SERVICE PARTS LIST

BULLETIN NO.
54-42-3303
DATE
Aug. 2014

| SPECIFY CATALOG NO. AND SERIAL NO. WHEN ORDERING PARTS | | REVISED BULLETIN | DATE |
|--|----------------------------|---------------------------|-----------|
| M12 BRUSHLESS COMPACT 2 SPEED SCREWDRIVER | | 54-42-3302 | Aug. 2014 |
| CATALOG NO. | 2402-20 | WIRING INSTRUCTION | |

**No. 23-94-2110
146mm Service Wire Assembly
(High Voltage Protection)**

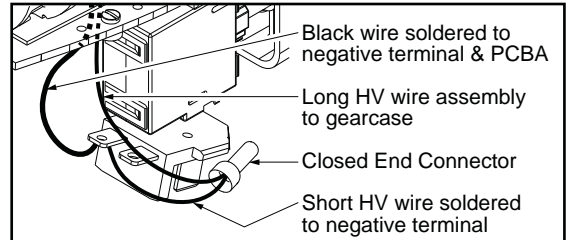
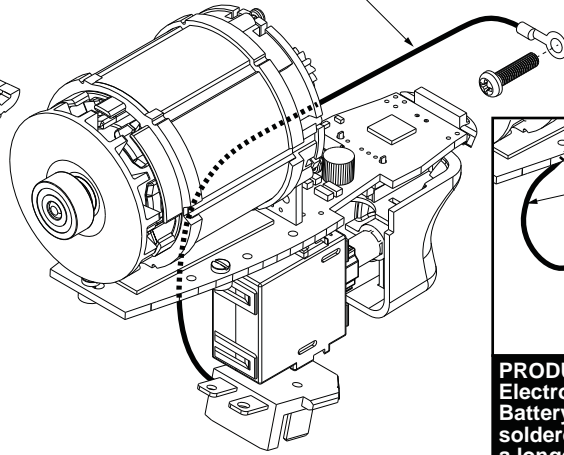
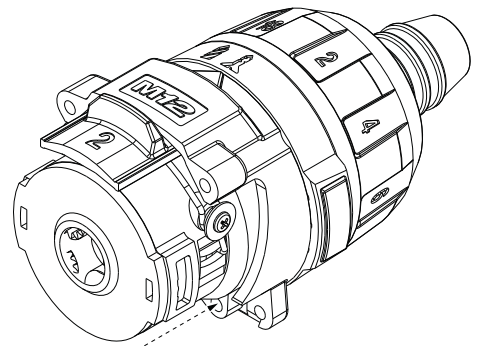
Black wire soldered to negative terminal & PCBA
Long HV wire assembly to gearcase
Closed End Connector
Short HV wire soldered to negative terminal

PRODUCTION WIRING- For ease in production, the Electronics Assembly (Switch, Stator, PCBA and Battery Terminal Block) has a short HV wire pre-soldered to the negative terminal. During production a longer HV wire is joined to the short wire with an open end connector than grounded to the gearcase.

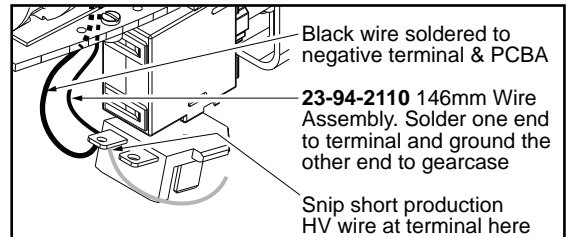
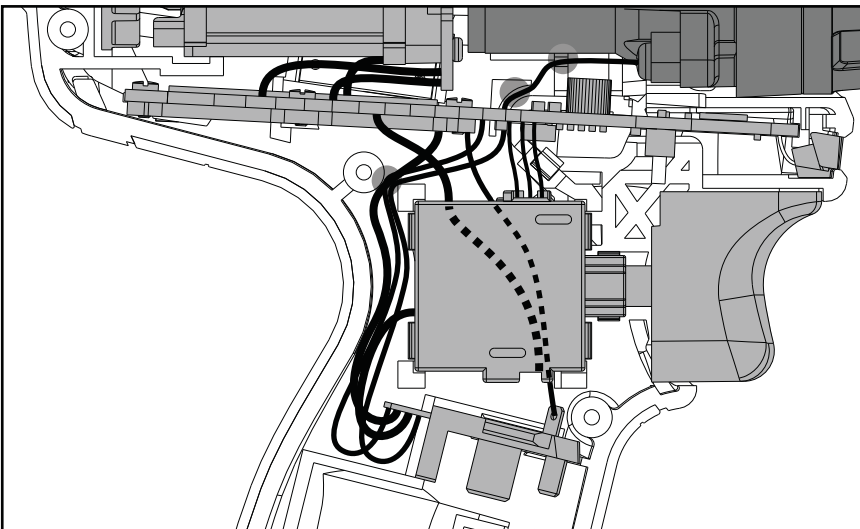
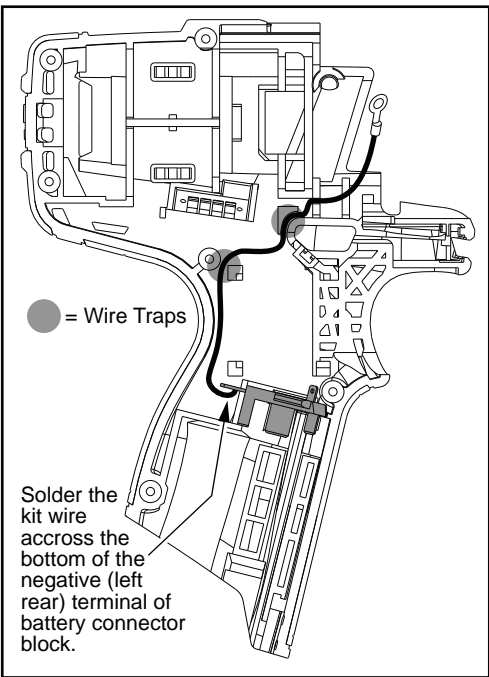
Black wire soldered to negative terminal & PCBA
23-94-2110 146mm Wire Assembly. Solder one end to terminal and ground the other end to gearcase
Snip short production HV wire at terminal here

SERVICE WIRING- When installing a service replacement High Voltage Wire (23-94-2110) it is recommended to snip the old HV wire system at the battery terminal. Remove and discard that short wire, the open end connector and longer wire. Follow the instructions to install new wire assembly.

Solder the kit wire across the bottom of the negative (left rear) terminal of battery connector block.

2. With a small side cutter, snip the short production HV wire close to the terminal (see illustration above). Unscrew the ring terminal from the lower right position of the gearcase. Remove and discard the old HV system (short HV wire, the open end connector and longer HV wire).

3. Place the wire strand end of the 146mm High Voltage Wire (23-94-2110) across the bottom of the negative (rear left) terminal of the battery connector block and carefully solder in place (Note wire is to be positioned so wire extends to the left of the terminal, routing into the left housing half). See illustration above.
